MILITARY SPECIFICATION

MICROCIRCUITS, DIGITAL, BIPOLAR, SCHOTTKY TTL,
ARITHMETIC LOGIC UNIT/FUNCTION GENERATORS,
MONOLITHIC SILICON

This amendment forms a part of MIL-M-38510/78A, dated 6 June 1984, and is approved for use by all Departments and Agencies of the Agencies of the Department of Defense.

FIGURE 1. Terminal connections and pin designations.

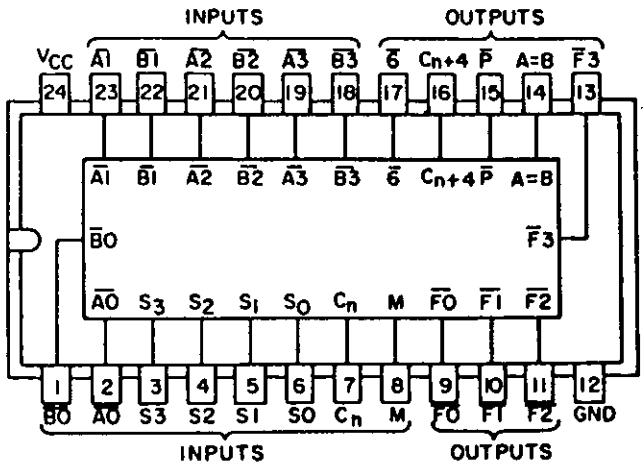
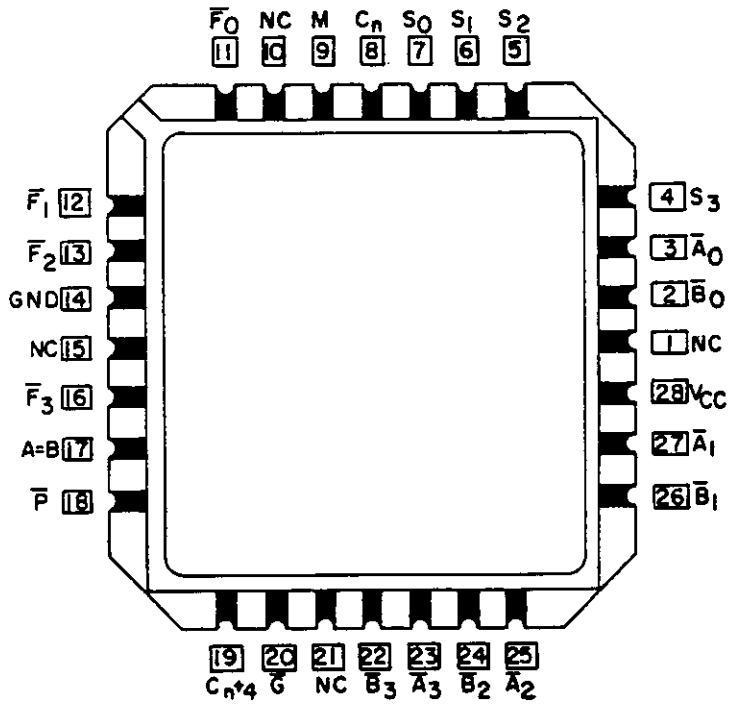
* 1.2.3, add the following case outlines:

"X C-4A (28-terminal, .450" x .450"), square chip carrier package
3 C-4 (28-terminal, .450" x .450"), square chip carrier package"

"5/ Cases 3 and X pins not designated are NC."
